Applicant: BEN MULLINS OBO / EUROPEAN AUTO GARAGE**Request:** BUILDING PERMIT**Meeting Date:** 8/9/2021**Address:** 1229 Lovell Rd.**Map/Parcel Number:** 118 H A 3502**Location:** West side of Lovell Road north of its intersection with Blanket Bay Way**Existing Zoning:** CA (General Business) / TO (Technology Overlay) and A (Agricultural) / TO (Technology Overlay)**Proposed Zoning:** N/A**Existing Land Use:** Auto repair facility**Proposed Land Use:** New storage building for facility (secondary use to the vehicle repair facility)**Appx. Size of Tract:** 5.03 acres**Accessibility:** Access is via Lovell Road, a 5-lane minor arterial with a 60-ft pavement width inside a 100-ft right-of-way.**Surrounding Zoning and Land Uses:** North: A (Agricultural) / TO (Technology Overlay) and PC (Planned Commercial / TO (Technology Overlay) - Vet office and single family residences

**8-A-21-TOB
CERTIFICATE OF APPROPRIATENESS**

CONCEPT PLAN
NEW STORAGE BUILDING
EUROPEAN AUTO GARAGE
1229 LOVELL ROAD
KNOXVILLE, TENNESSEE

LAYOUT & CIRCULATION PLAN

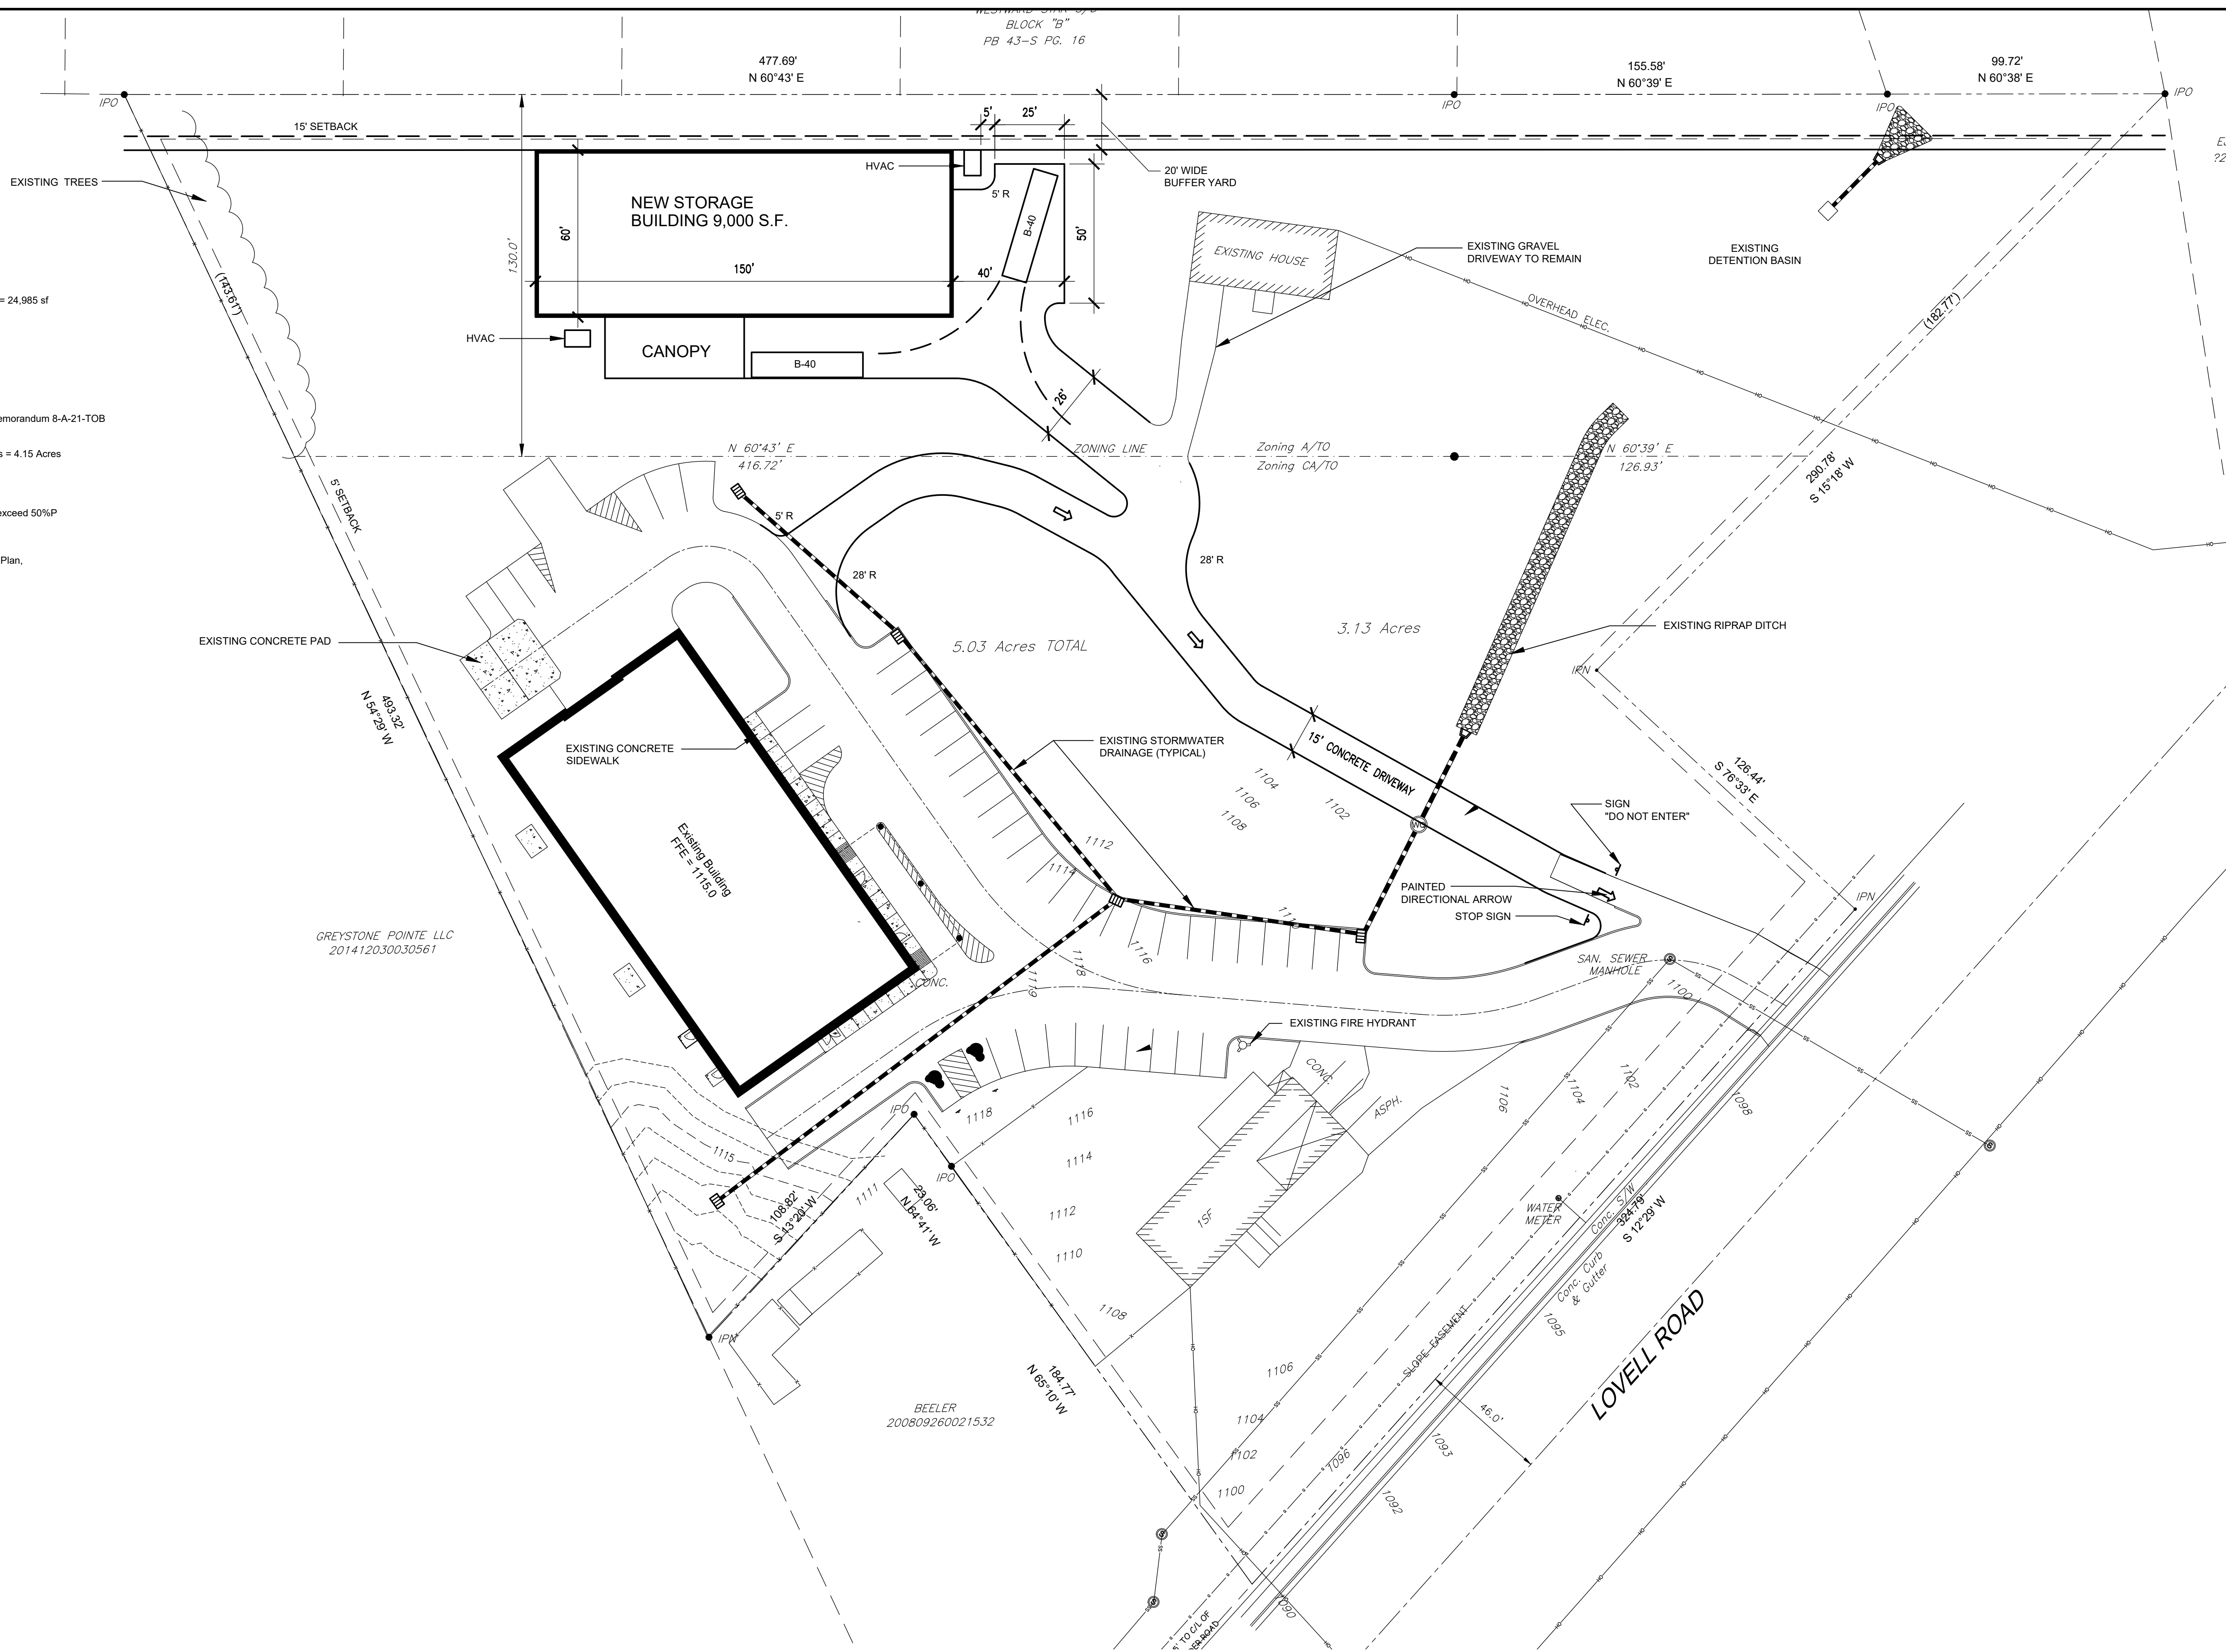
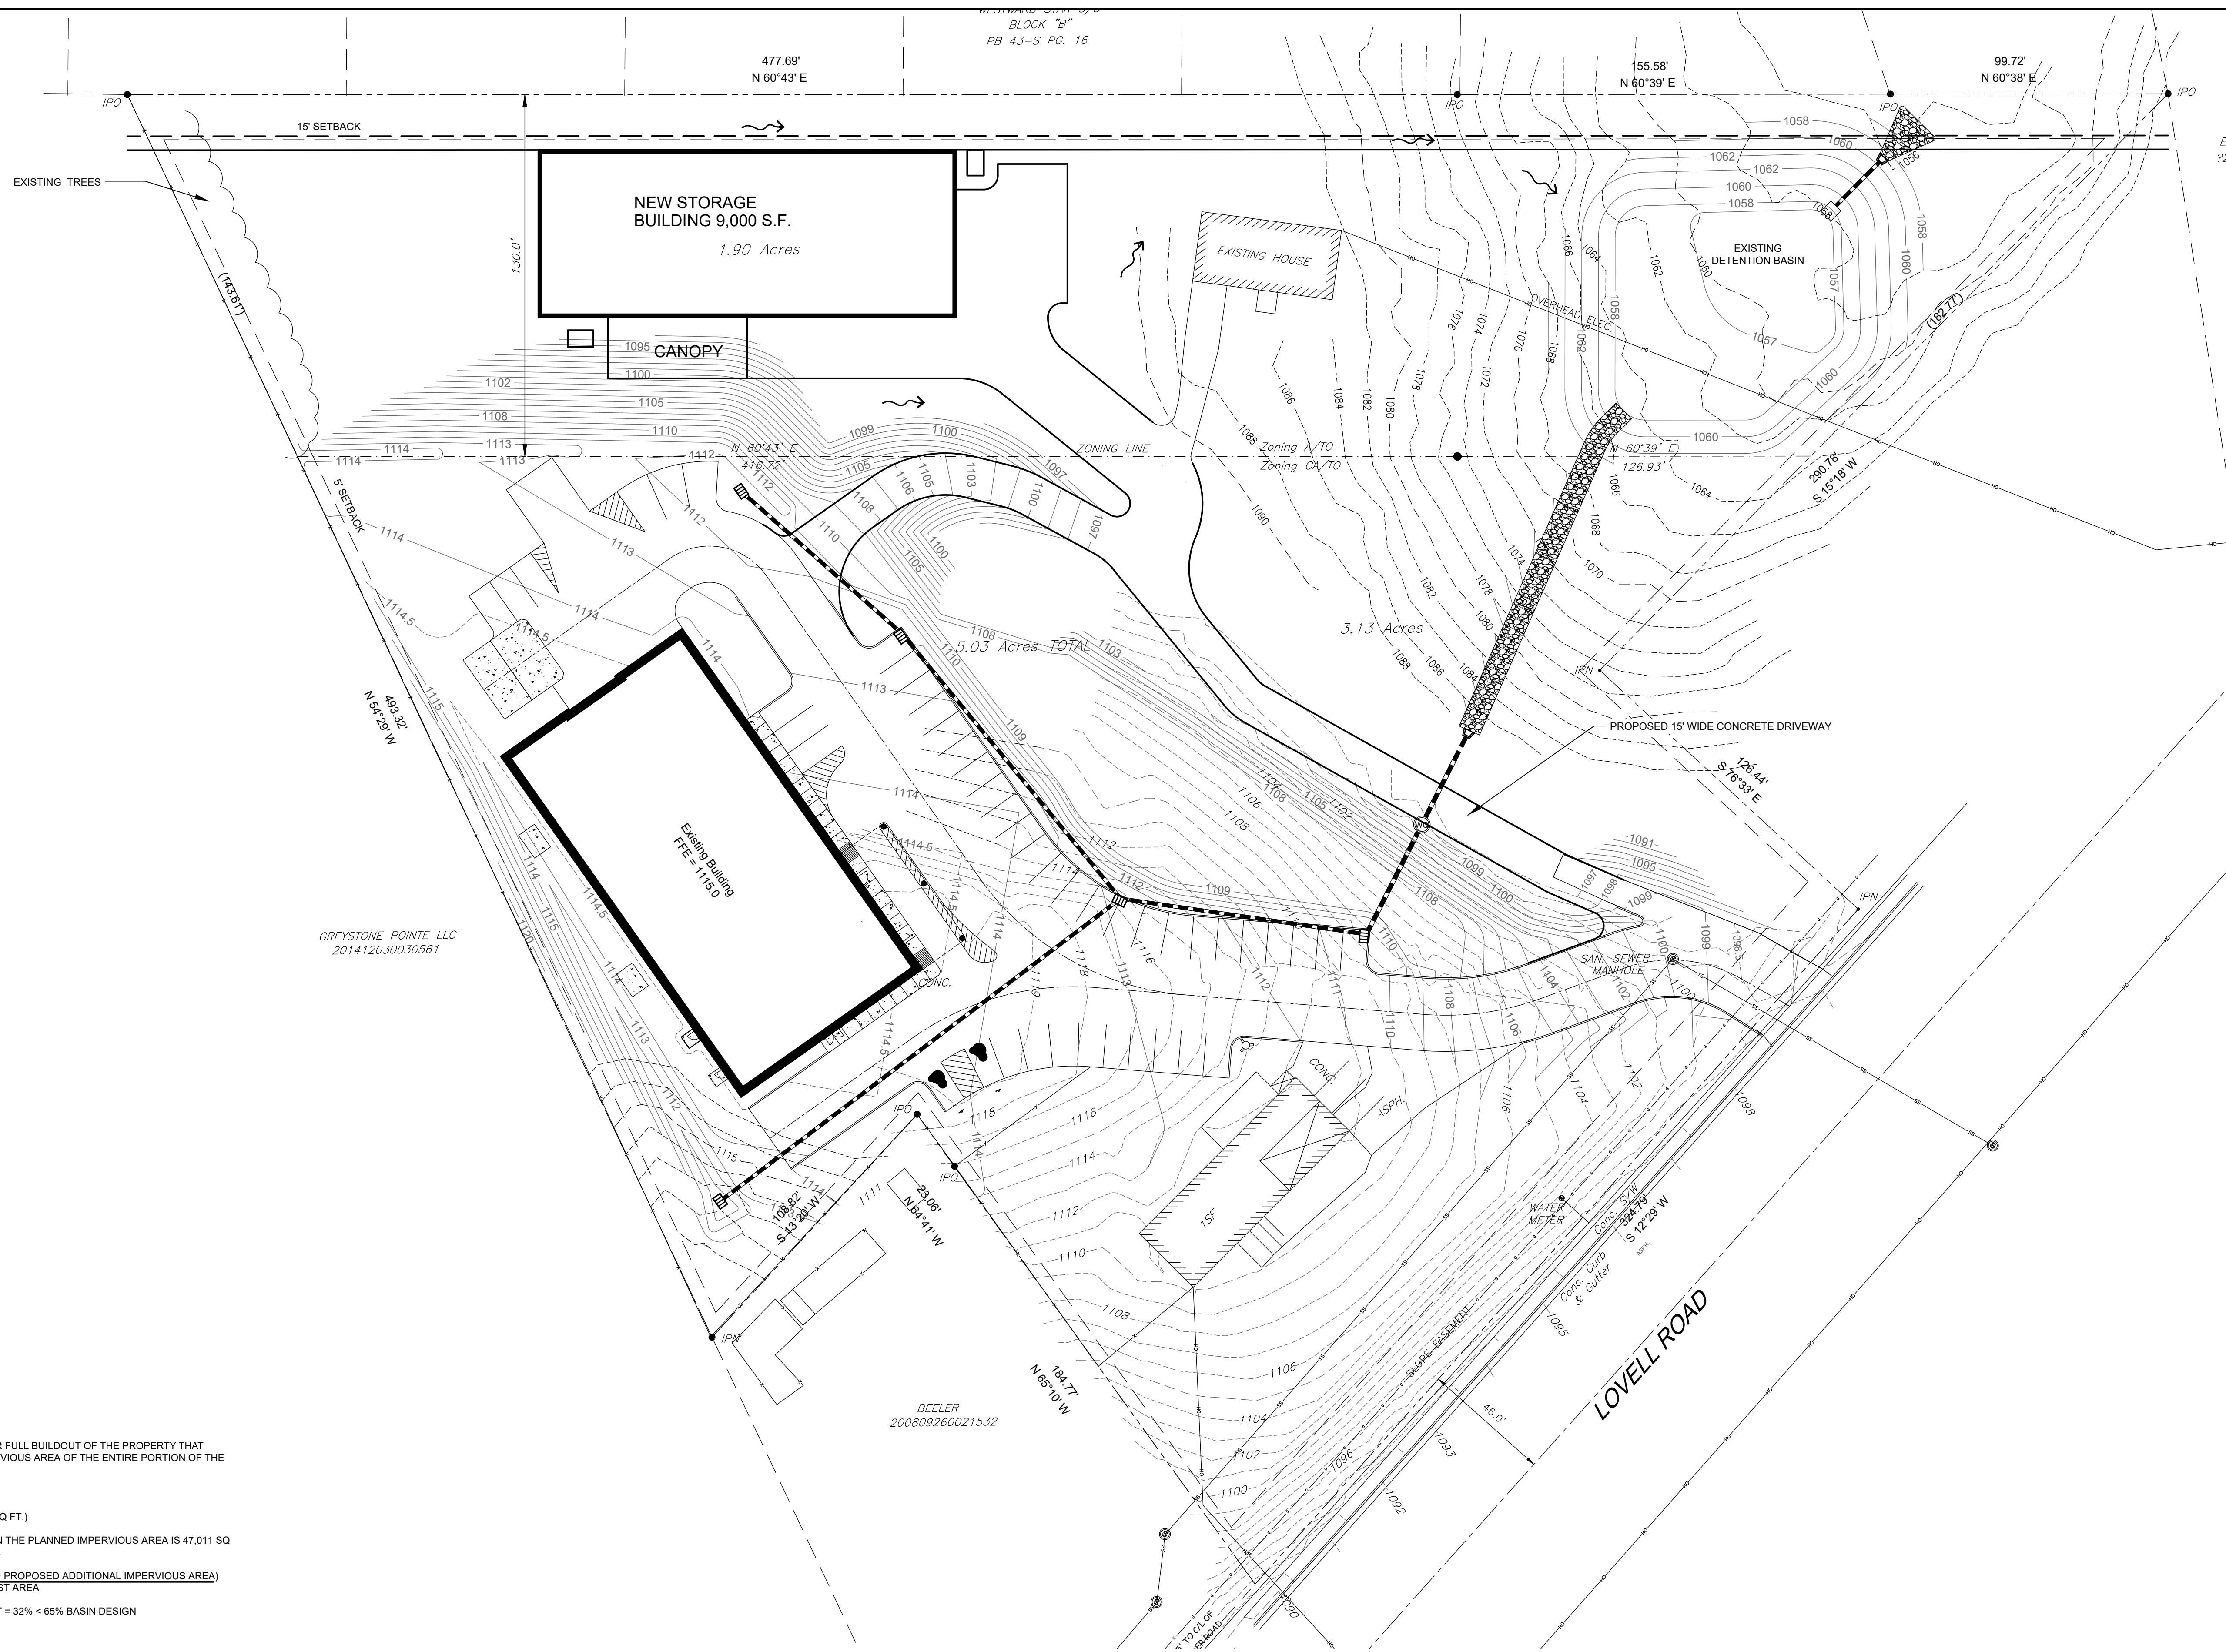
- 7) Due to site constraints, the new building would be located closer to the northern property line than the setback requirements would allow. As proposed, the new building is proposed 20 ft from the northern property line instead of the 100 ft that is required when adjoining a residential zoning district. A waiver is required to reduce the required setback to 20 ft, which is the standard side yard lot line setback for TTCDA. Since the applicant is proposing the "Type A - Dense" landscaping buffer (required in the County when commercial businesses abut residential districts) along the northern lot line adjacent to residential lots, the building will be screened from view and staff recommends approval of the setback waiver.

- 1) APPROVE the waiver to reduce the setback for the shared residential property line on the north to 20 ft. due to site constraints and because the area proposed for the new building does contain any significant slope.

Applicant requests a waiver for section 1.4.1 to reduce the setback on the northern side of the site from 100ft to 20ft.

The proposed Property complies with the existing rear setback (20') for the existing Agricultural Zone, but is planned within the 100' Setback in the TO overlay when the property line abuts residential zone. As the abutting northern property is AG, agricultural, which allows for residential development on one acre lots¹, then it is Knox County's interpretation that the AG zone is considered a residential zone if it is developed with residential lots. Nevertheless, there is ample justification for granting a waiver from this setback.
